RE: SDCC REG. REF. SDZ22A/0005

PLANNING APPLICATION FOR THE PROVISION OF 436 NO. DWELLINGS (UP TO A MAXIMUM OF C. 37,402M GFA INCLUDING CAR PARKING) IN DEVELOPMENT AREA 11 – ADAMSTOWN STATION

RESPONSE TO REQUEST FOR FURTHER INFORMATION

Figure 1: Extract from Technical Note, prepared by Atkins Consulting Engineers showing 3no. bus layby areas and turning area on Station Road.

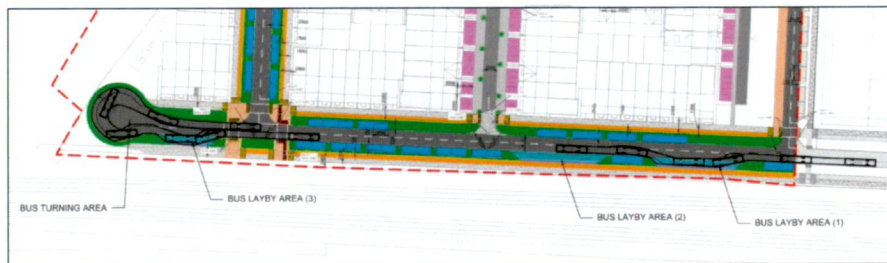
(g) The applicant is requested to provide details of bus set down areas.

(g) We refer the Planning Authority to page 9 of the enclosed Technical Note, prepared by Atkins Consulting Engineers which outlines the bus set down and turning areas on Station Road.
